# ARCHITECT'S SUPPLEMENTAL INSTRUCTION NO. 4

**DATE:** November 07, 2023 **PROJECT NO: 230117**

RE: Streets of West Pryor - Lot 5 Core & Shell

WALL FRAMING PLAN

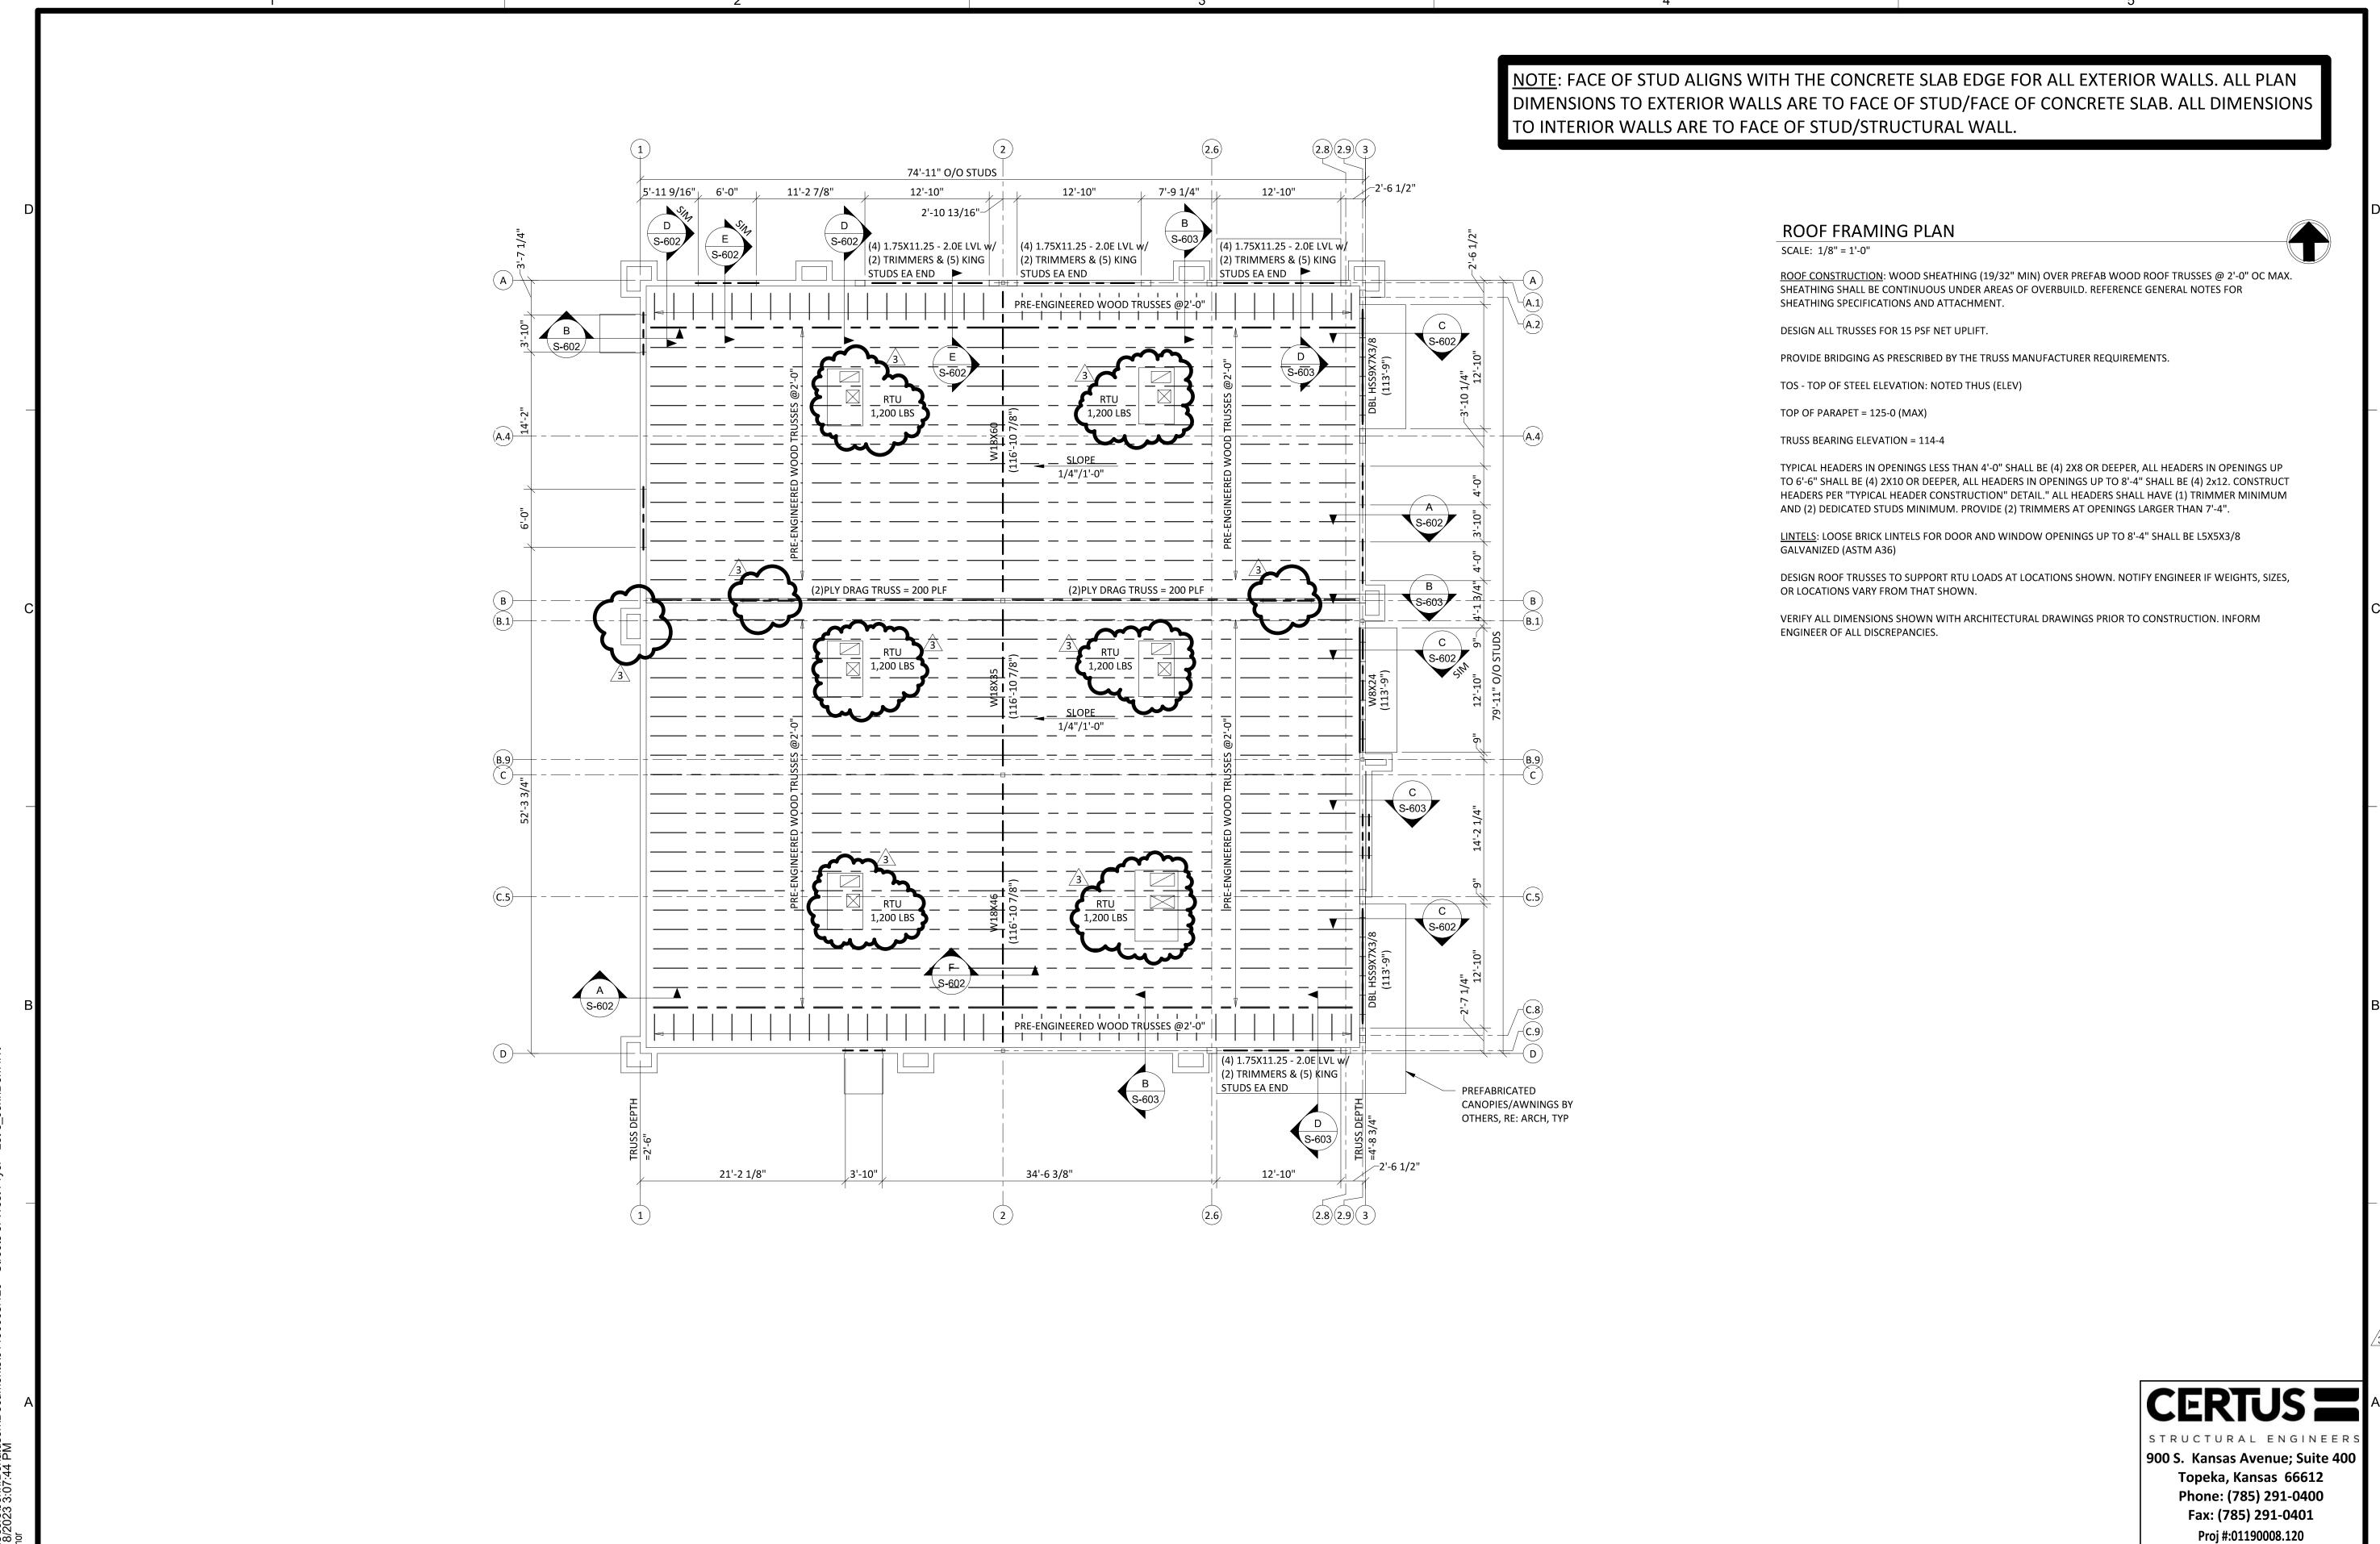
S-1 Sheet S-102 - Updated location of future pass-through openings on Suite C's South demising wall.

SHEET NUMBER
S-103

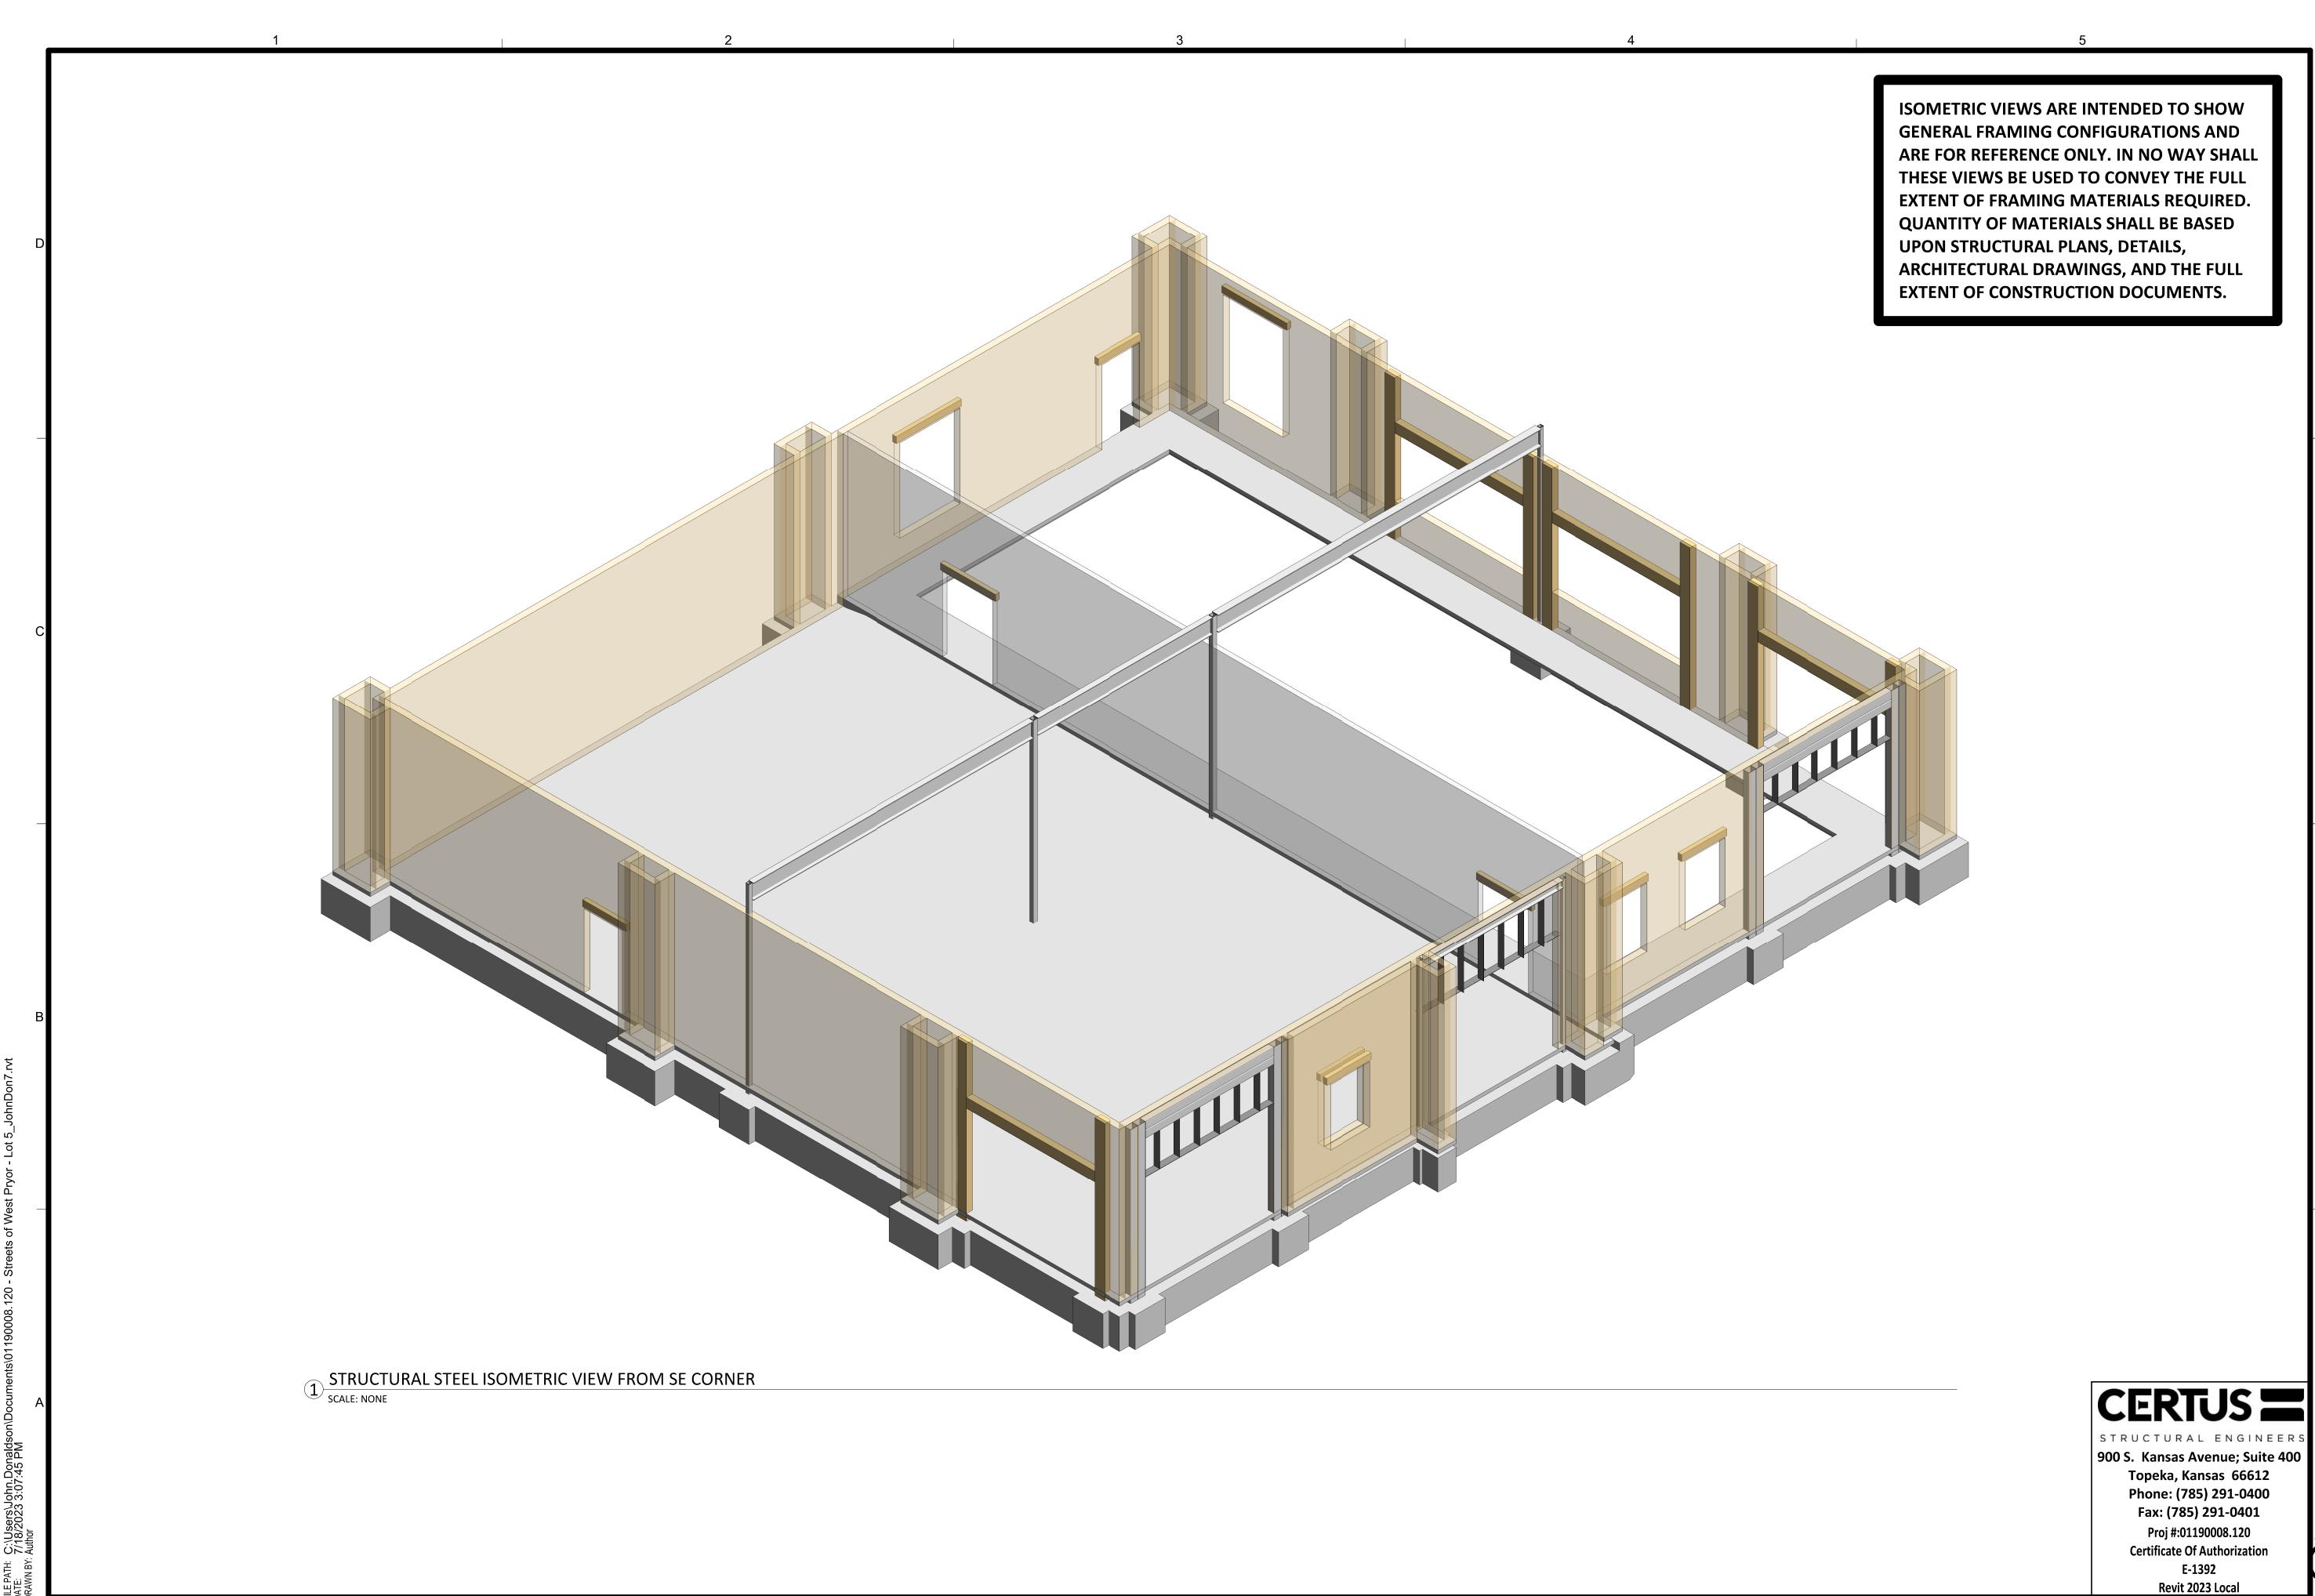
- S-1 Sheet S-001 Updates to general notes Risk Category and Wind Load information.
- S-2 Sheet S-101 Foundation updates to columns B.1-3 & B.9-3 and dimensional spacing on East.
  - S-2.A Addition of West pilaster foundation.
- S-3 Sheet S-102 Future pass-through openings added to shearwall
  - S-3.A Wood shearwall schedule updated.
  - S-3.B Addition of West wall pilaster.
- S-4 Sheet S-103 RTUs rotated 90 degrees for structural support.
  - S-4.A Future pass through openings located in shearwall.
  - S-4.B Addition of West wall pilaster.
- S-5 Sheet S-201 Updated shearwall pass-through openings and west wall pislater added to isometric.
- S-6 Sheet S-301 Bolt type and dimensional location update to Baseplate Details drawings BP-2.

SHEET NUMBER
ME-202

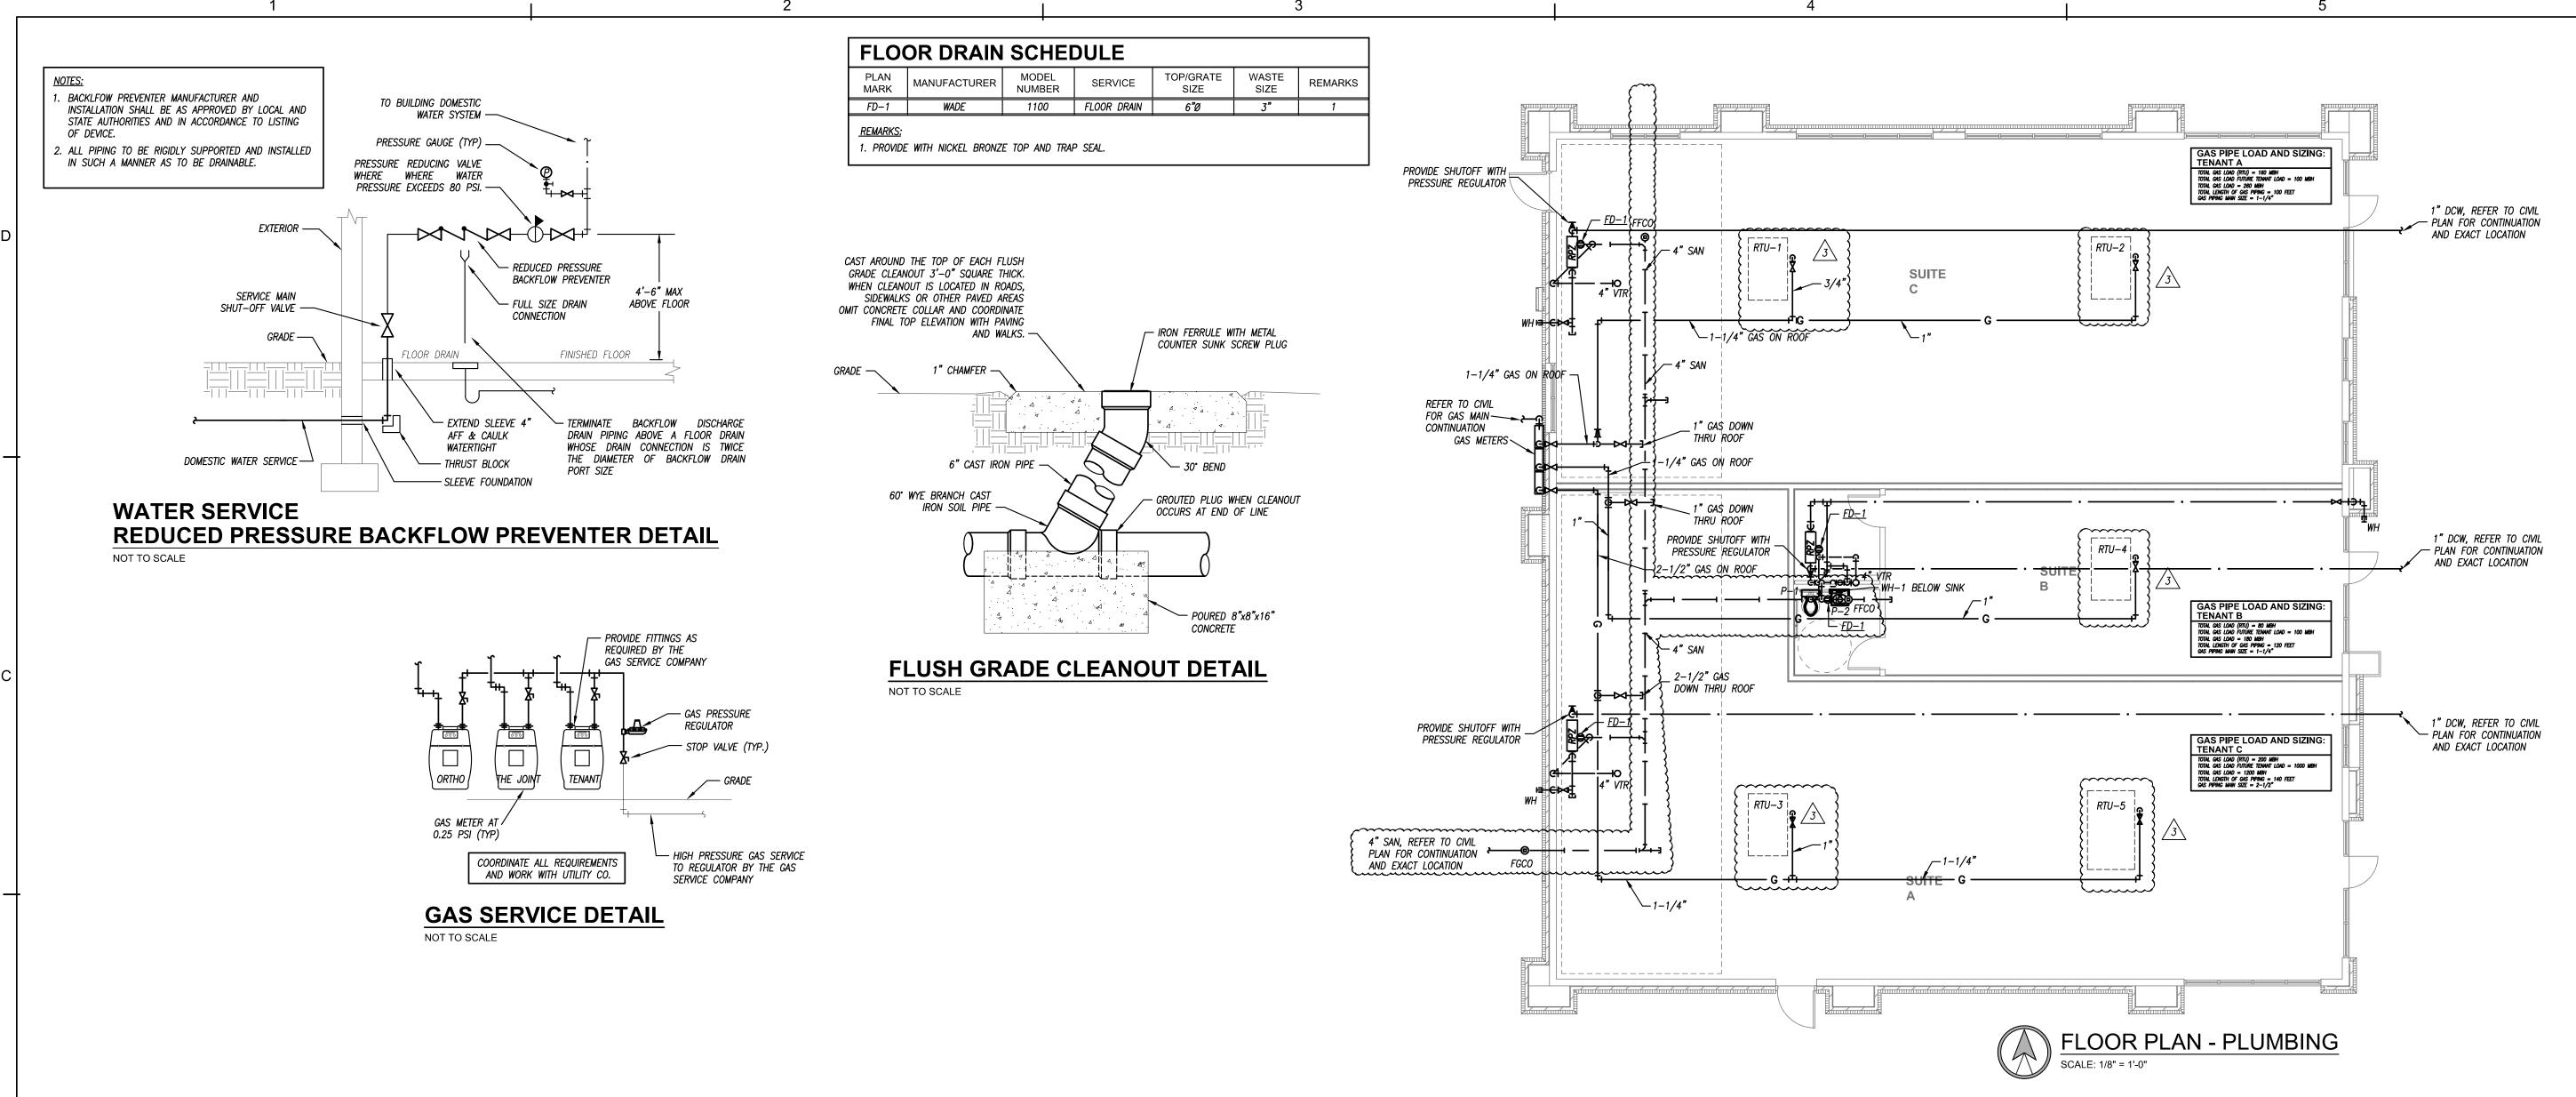
- MEP-1 Sheet ME-201 Updates to Light Fixture Schedule to show "C" fixtures on exterior. MEP-1.A Movement of Light Poles.
- MEP-2 Sheet ME-202 Updated placement of exterior utilities
- MEP-3 Sheet M-101 Swapping the respective placement of RTU 3 and RTU 4 for each other. MEP-3.A Rotation of RTU units
- MEP-4 Sheet M-201 Rotation of RTU units
- MEP-5 Sheet E-101 Swapping the respective placement of RTU 3 and RTU 4 for each other.
